APPLICATION FOR SOIL INVESTIGATION

Re: Property located at Henderson Circle South, Lot 10-E

SITE EVALUATION

OWNER: Laney Homes Inc.
ADDRESS: 1443 S. Boulevard Charlotte, N.C. 28203
PLAT NO: 10-E
LOT SIZE: 14,320
LOCATION OF SITE: Henderson Circle

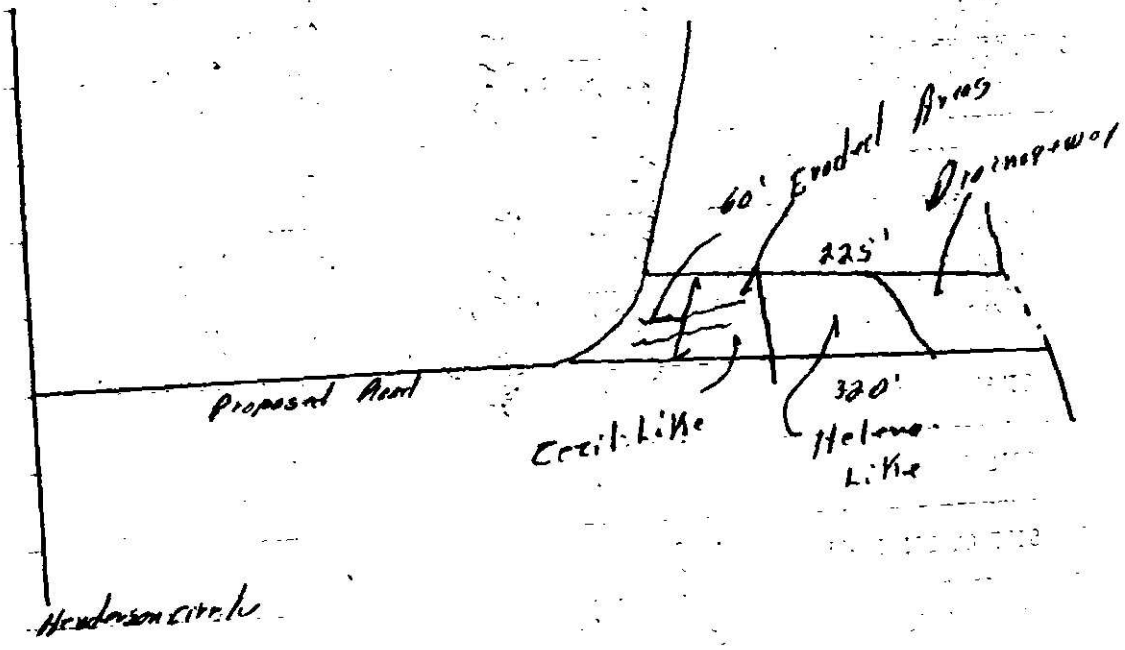
FACTORS	AREA 1	AREA 2	AREA 3	AREA 4
1. SLOPE (%)	(S) PS U — 8-15%	(S) PS U — 8-15%	(S) PS U — 36%	S (PS) U
2. SOIL TEXTURE (12-36 inches) Sandy, Loamy, Clayey (Note 2-1 Clay)	S (PS) U — clay	S PS (U) — 2-1 clay	S (PS) U — clay loam	S PS U

3. SOIL STRUCTURE (12-36 inches)	S (PS) U — Blocky	S (PS) U — Weak Blocky	S (PS) U — Blocky	S PS U
4. SOIL DEPTH (inches)	S (PS) U — 36-48"	S PS (U) — 24-36"	S (PS) U — 36-40"	S PS U

5. RESTRICTIVE HORIZONS (Inches) (Impervious strata, Rock)	S (PS) U — Saprolite 36"+	S PS (U) — Saprolite ± 36"	S (PS) U — 36"+	S PS U
6. SOIL DRAINAGE/GROUNDWATER (external and internal)	S (PS) U — 36"+ to ground water	S PS (U) — Perched water table 24-36"	S PS (U) — Drainage way	S PS U

7. OTHER (Specify)	S PS (U) — Restrictive Area	S PS U	S PS U	S PS U
8. SOIL GROUP	IVA	IVB	IVA	
9. SITE CLASSIFICATION	unsuitable	unsuitable	unsuitable	
10. SOIL SERIES	Cecil-like	Herndon-like	Drainageway

Recommendations/Comments: inadequate lot size

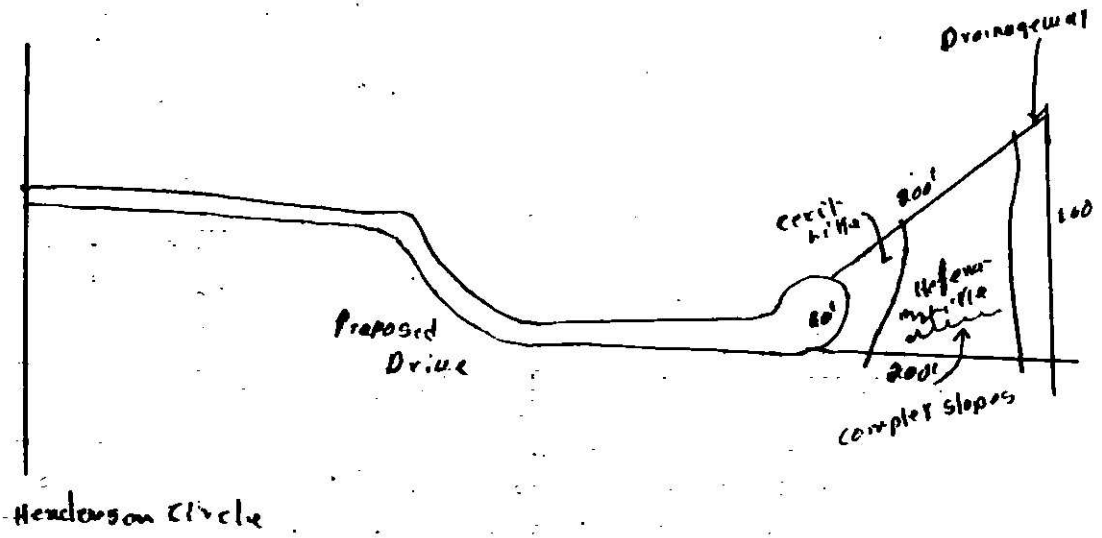
FACTORS	AREA 1	AREA 2	AREA 3	AREA 4
1. SLOPE (%)	S (PS) U — 6-12%	S (PS) U — 2-12%	S PS (U) — complex slopes	S PS U —
2. SOIL TEXTURE (12-36 inches) Sandy, Loamy, Clayey (Note 2-1 Clay)	S (PS) U — clay	S PS (U) — 2:1 clay	S PS U —	S PS U —

3. SOIL STRUCTURE (12-36 inches)	S (PS) U — blocky	S (PS) U — blocky	S PS U —	S PS U —
4. SOIL DEPTH (inches)	S (PS) U — 36-40"	S (PS) U — 24-36"	S PS U —	S PS U —

5. RESTRICTIVE HORIZONS (Inches) (Impervious strata, Rock)	S (PS) U — 36"	S PS (U) — 36"	S PS U —	S PS U —
6. SOIL DRAINAGE/GROUNDWATER (external and internal)	S (PS) U — 36" to ground water	S PS (U) — perched water table 24-30"	S PS (U) — eroded areas channel	S PS (U) — driveway

7. OTHER (Specify)	S (PS) U — restricted areal	S PS U	S PS U — no soil	S PS U
8. SOIL GROUP	IVA	IVB	—	—
9. SITE CLASSIFICATION	unsuitable	unsuitable	unsuitable	unsuitable

10. SOIL SERIES	Cecil-Pacolet	Helena-Pacolet	complex slopes	Drainageway
